**WATER QUALITY IMPACT ASSESSMENT
(CBPO ARTICLE 6 WRPA SUBMISSION)
6630 HOLLAND STREET
FAIRFAX COUNTY, VIRGINIA
RPA EXCEPTION REQUEST #129-WQ-001-3**

Reference: WRPA CBPO Article 6 Statement of Justification for WQIA #129-WQ-001, 6630 Holland Street, Fairfax County, Virginia
Latitude: 38° 57' 31" N, Longitude: 77° 10' 21" W

Reference: Resource Protection Area (RPA) Exception Request # 129-WQ-001-3

Reference: Water Quality Impact Assessment # 129-WQ-001-2

EXISTING CONDITIONS (2019)

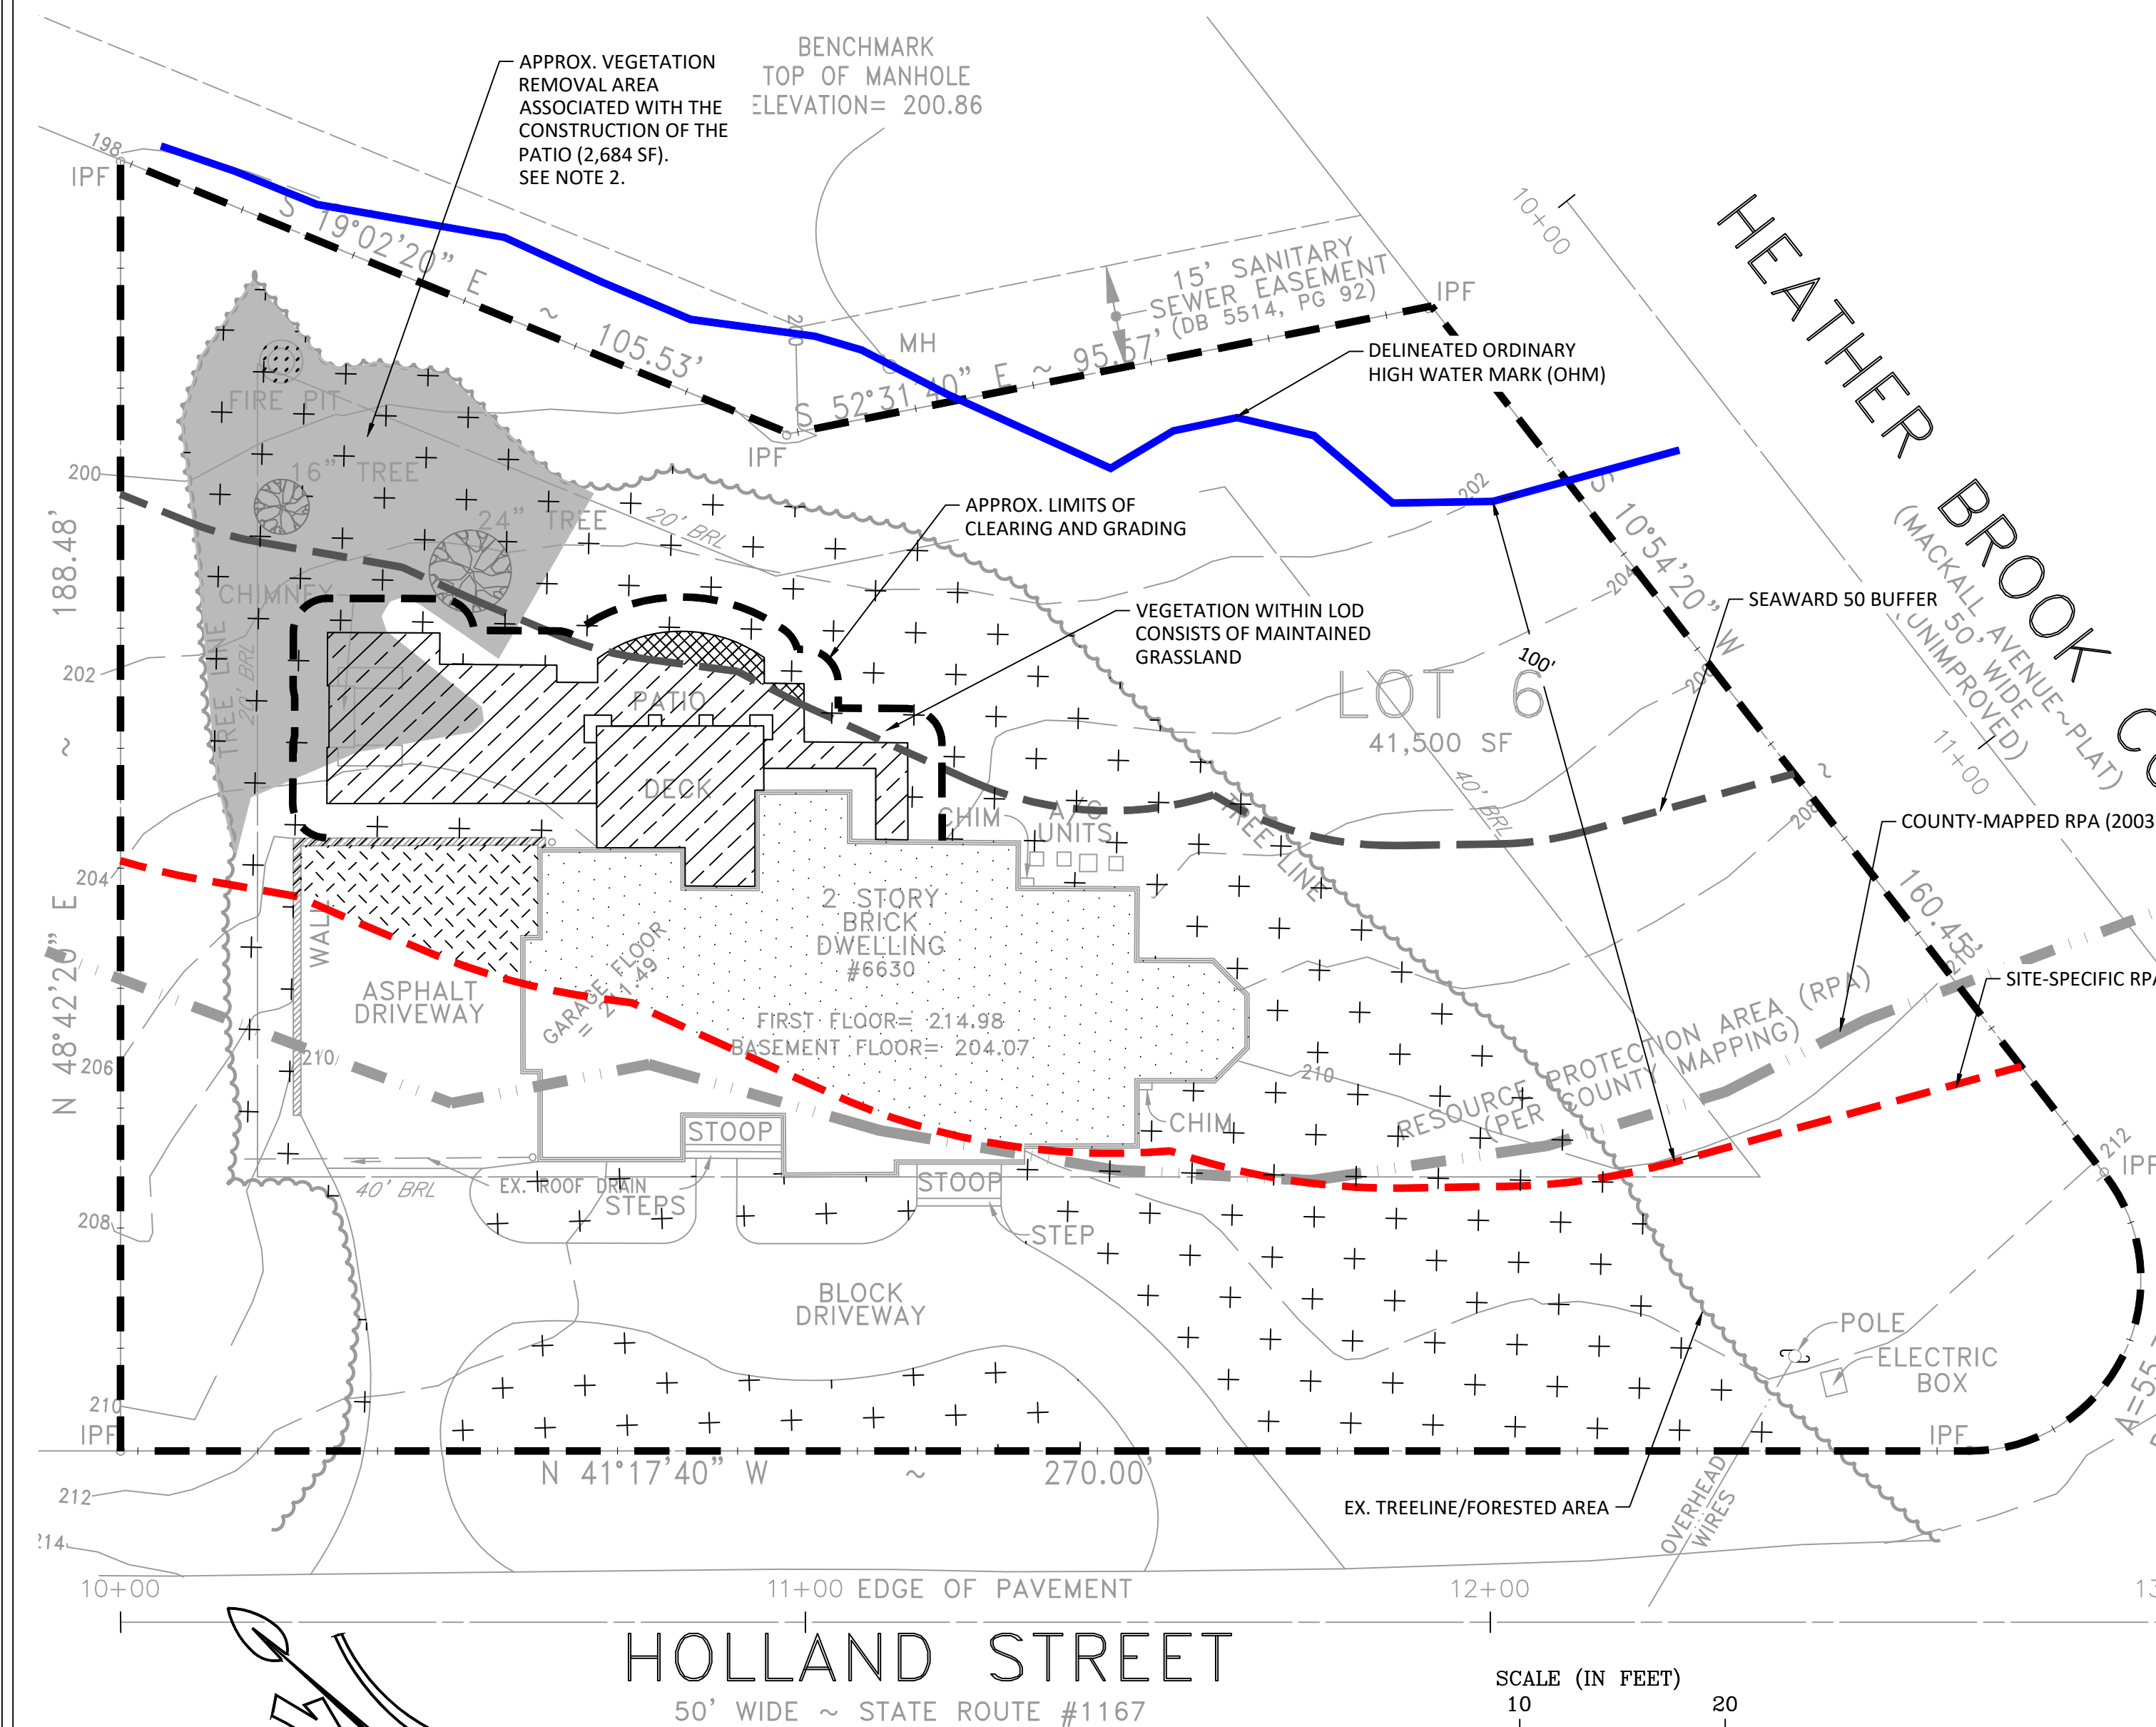
10. Show the existing vegetation on the “Existing Conditions (2019)” exhibit.

SHEET 4 OF 5

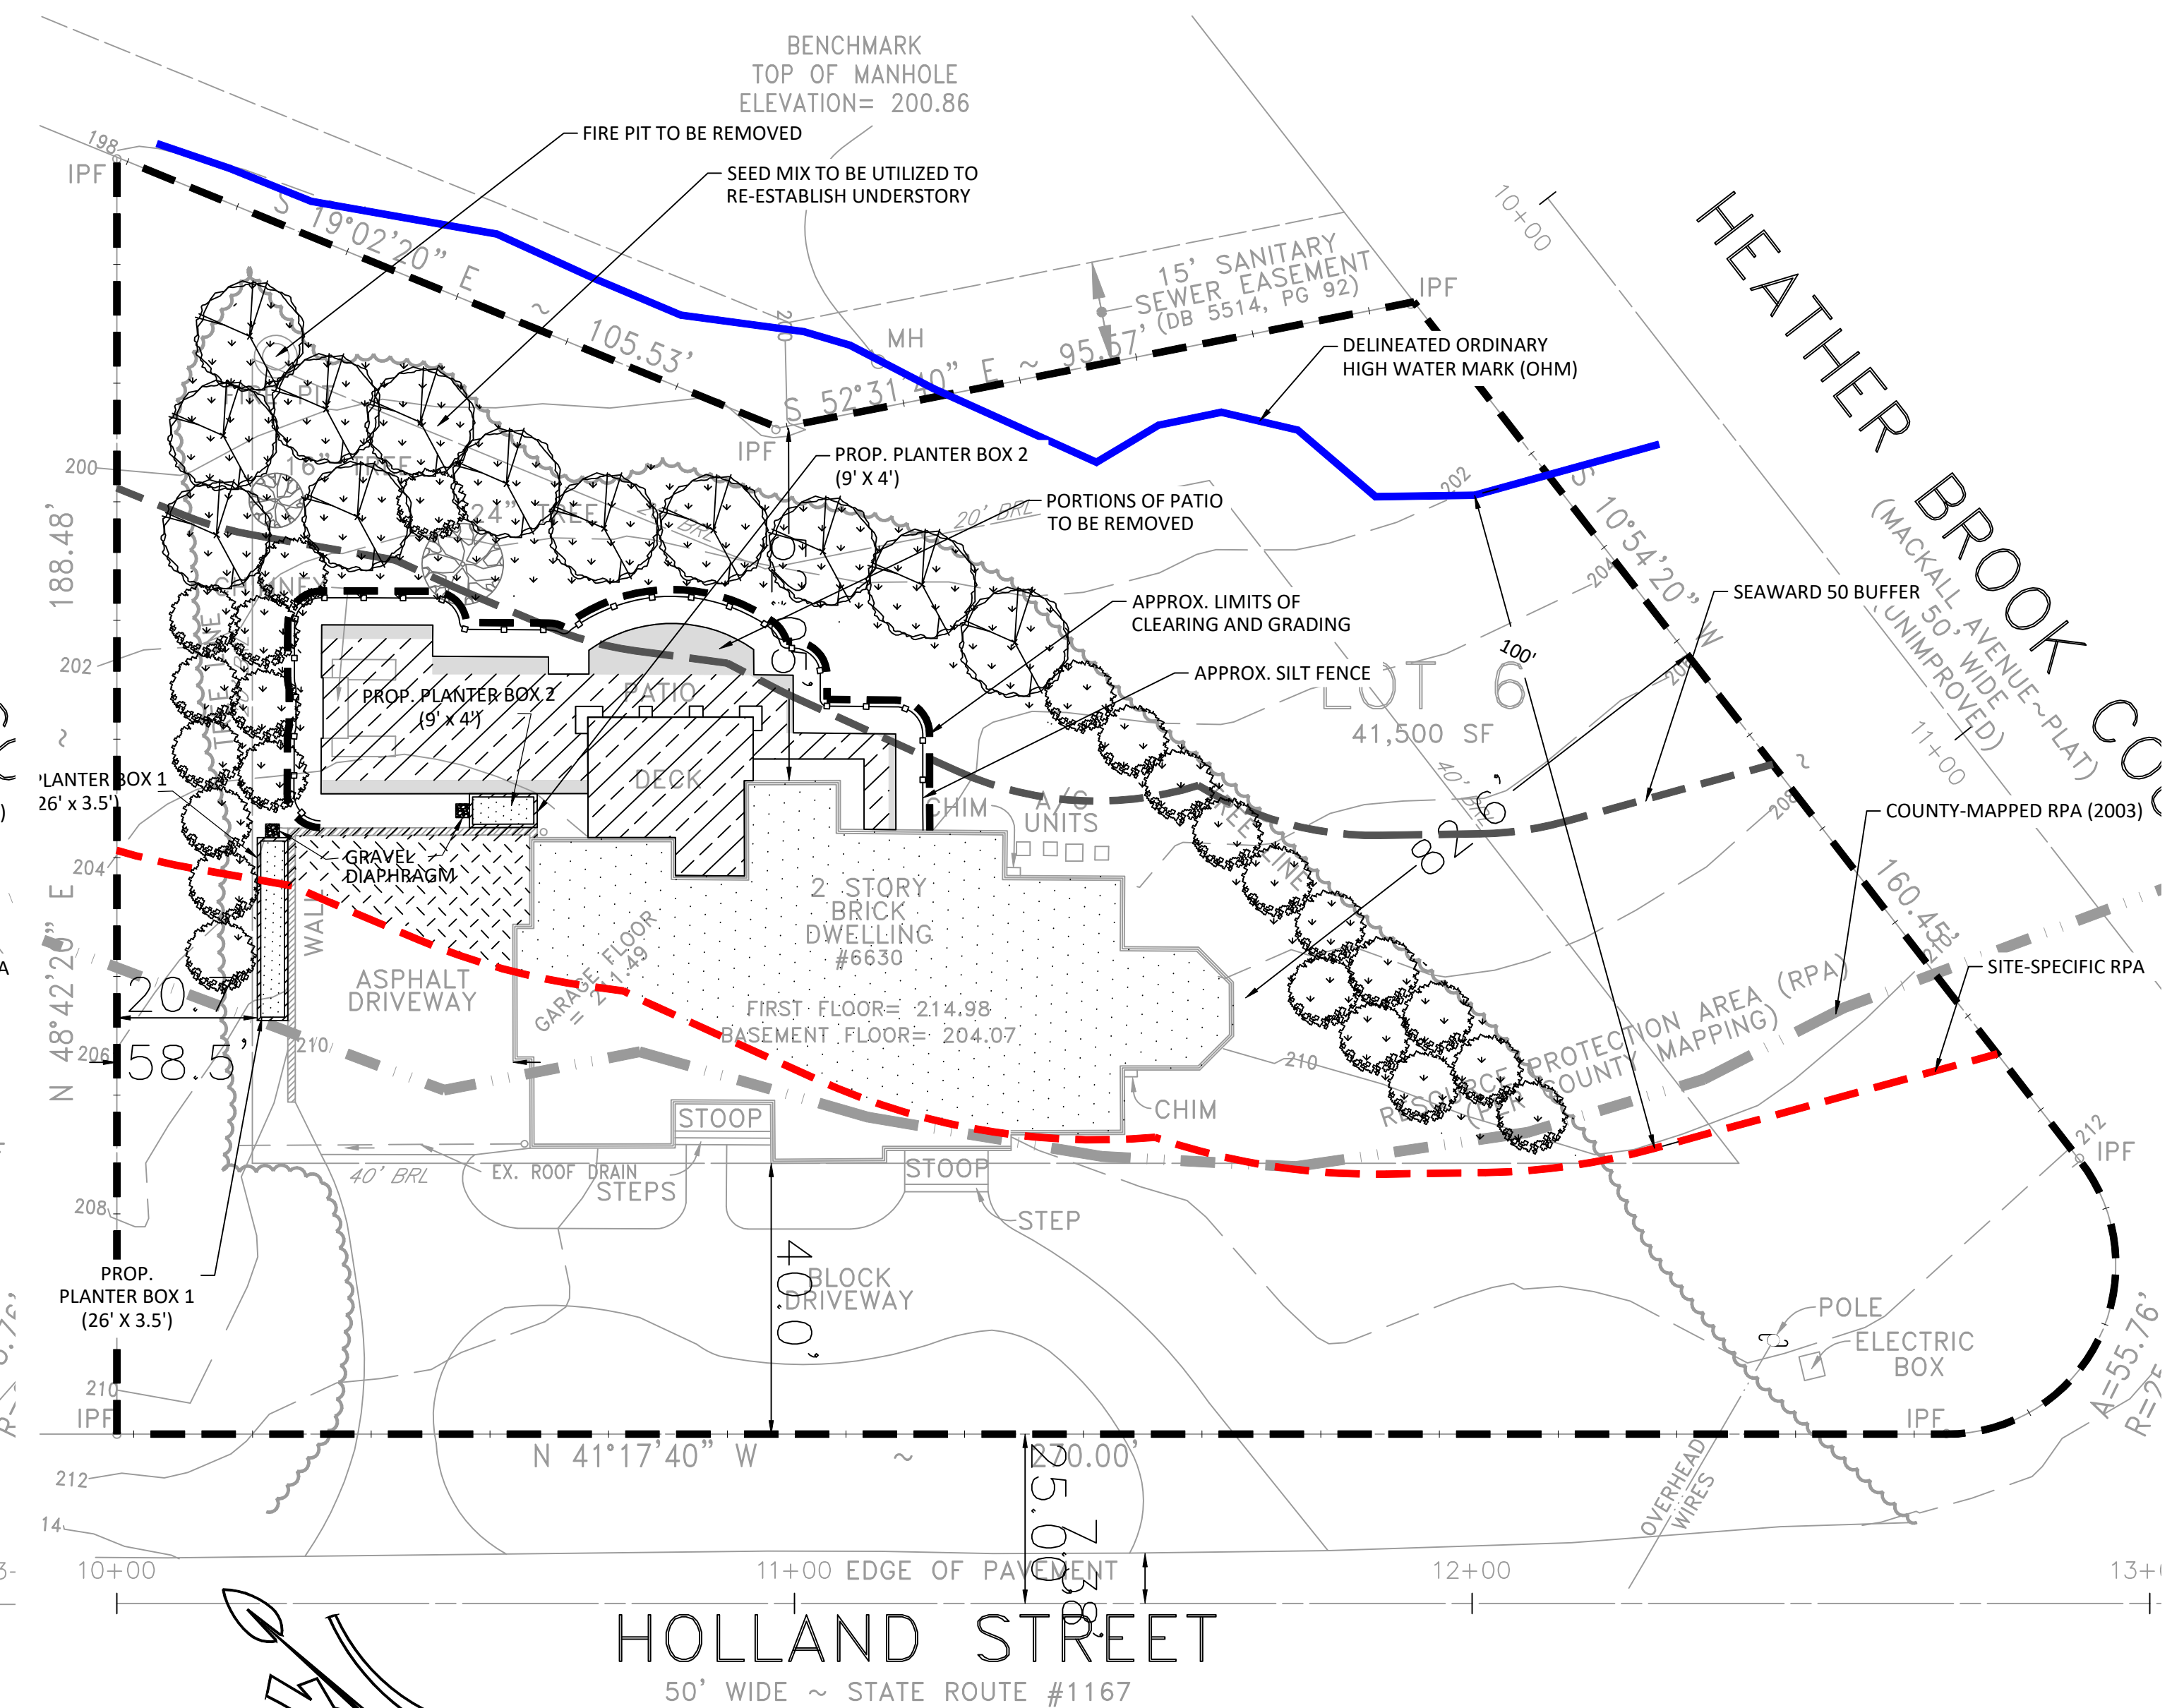
5. The following information is missing from sheet 4 (ZO 9-011):
 - i. Boundaries of entire property, with bearings and distances of the perimeter property lines.
 - ii. Show all minimum yards, and the distances from existing structures to the lot line.
 - iii. Delineation of the existing centerline of all streets abutting the property, including dimensions from the existing centerline to the edge of the pavement and to the edge of the right-of-way.
 - iv. The approximate on-site and off-site areas to be served by each stormwater management facility, along with the acreage draining to each facility.

- v. A preliminary stormwater management narrative: a statement that the project is exempt for Chapter 124 and why.
- vi. Show the calculation of percent increase in impervious surface on-site and types of surfacing materials used on the plan.
- vii. Include a statement on Sheet 4 “that all selected plants are indigenous species appropriate for the riparian buffer to the extent practicable”.

12. Clarify any plant material to be removed and show it on Sheet 4.
